AEP-NRC-2015-50
10 CFR 50.90

Donald C. Cook Nuclear Plant Unit 1
Response to a Request for Additional Information Regarding the Emergency License
Amendment Request to Extend the Allowed Outage Time
for an Emergency Diesel Generator

Response to Request for Additional Information Regarding One Time Emergency License Amendment Request to revise Technical Specification Section 3.8.1 to permit extending the Completion Time. (RAI-EEEB-1 and 2)

FSAR Figure 8.1-2-2A:

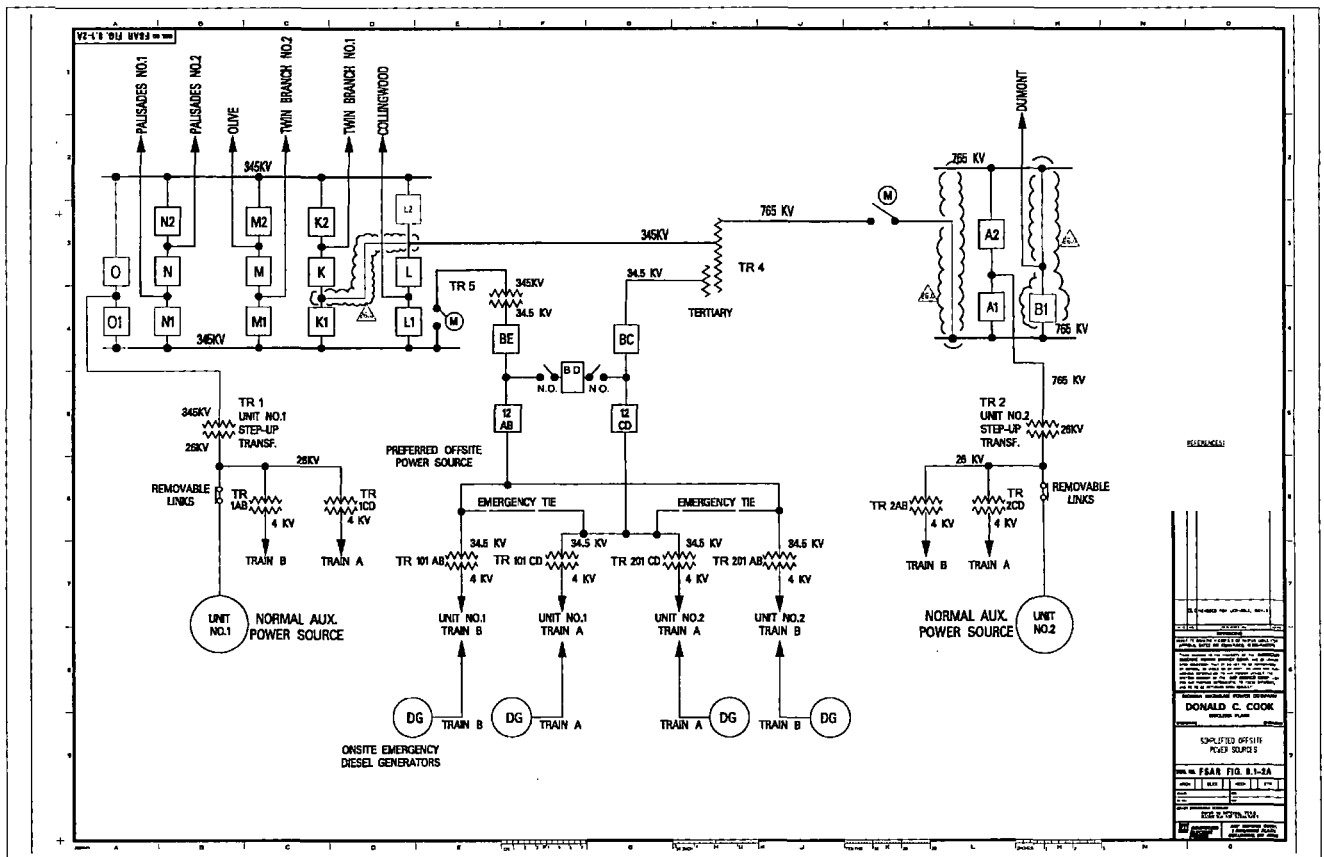
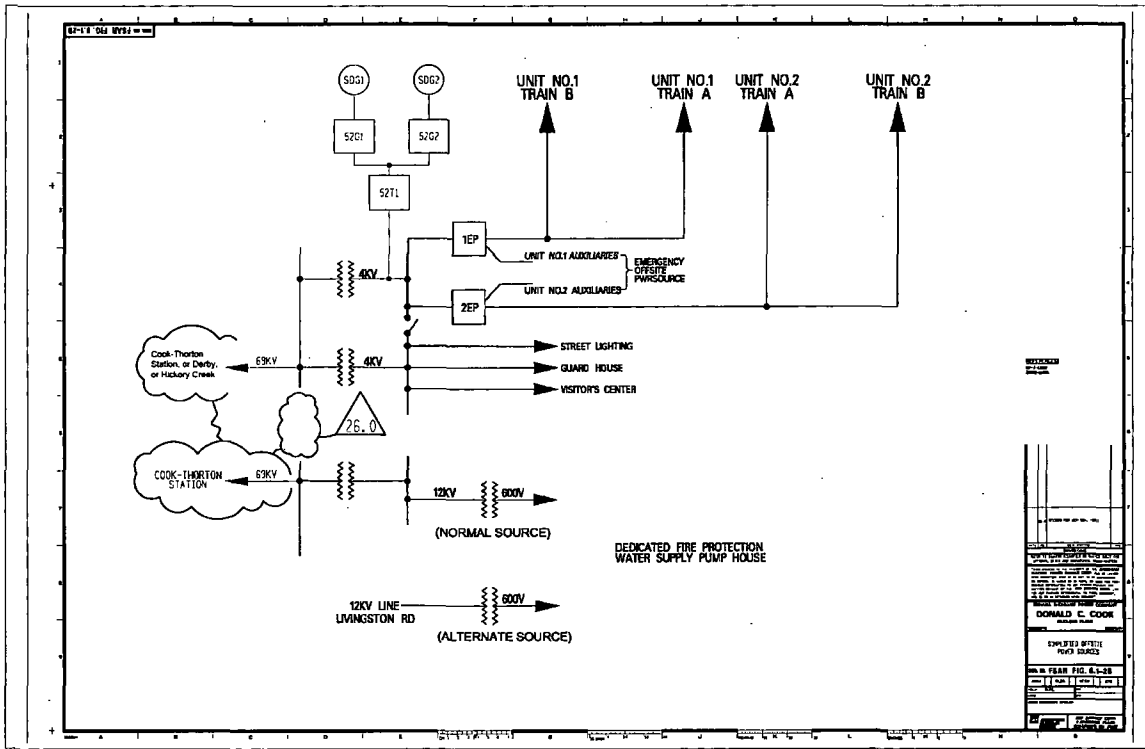
Please discuss in detail how CNP Unit 1 mitigates the consequences of the following events when plant is operating with one EDG in maintenance for 65 days. Please identify all additional power sources that are available and will be credited for mitigating the events described below for the duration of the extended outage including the operating procedures in place and the operator training completed. Please identify the capacity of the power sources, their alignment and the actual loads required to be connected, including the fuel oil requirement and storage for 65 days.

- a. Loss of offsite power (LOOP)*
- b. Station Blackout*
- c. LOOP with LOCA and a single failure of the operable EDG*

Description of power to 4kV Safety Buses

Unit auxiliary power is distributed from the 4160 volt switchgear which is energized from the main generator through unit auxiliary transformers TR1AB and TR1CD during normal operation, and from Preferred Offsite Power Source reserve auxiliary transformers (RATs) TR101AB and TR101CD during start-up or shutdown operations. The 4160 volt system is duplicated for Unit 2.

The 4160 volt buses (T11A, T11B, T11C, and T11D) may also be fed from a 4160 volt diesel generator, to supply power to the engineered safety features and other necessary equipment in the event of a LOOP. There are two diesel generators associated with each unit. Each diesel generator is connected to two 4160 volt buses, one to buses T11A and T11B and one to buses T11C and T11D. Upon loss-of-power to a 4160 volt bus, the associated diesel generator starts automatically. The circuit breaker, which normally supplies power to that bus from the main 4160 volt bus, is tripped. A 4160 volt circuit breaker in each bus is automatically closed when each diesel generator's voltage and speed approach rated values, and re-energizes the bus. The continuous service rating of each DG is 3500 kW. The diesel generators will then supply all equipment which must operate under emergency conditions (accident loads). The accident loads consist of the following:

The alternate offsite power source (alternately referred to as EP) has been provided by a 69 kV line that is fed from two separate transmission lines, Bridgman and Derby. This bus feeds the 69/4160 kV transformer TR12EP-1 and the 4160 volt main bus cables are run underground to connect to buses T11A, T11B, T11C, T11D, and T21A, T21B, T21C, and T21D. This

transformer has been sized to provide necessary capacity to operate one train of the engineered safeguards equipment in one unit while supplying one train of safe shutdown power in the other. The breakers which connect this source to the 4160 volt bus are manually operated and interlocked to prevent parallel operation with any other 4160 volt source.
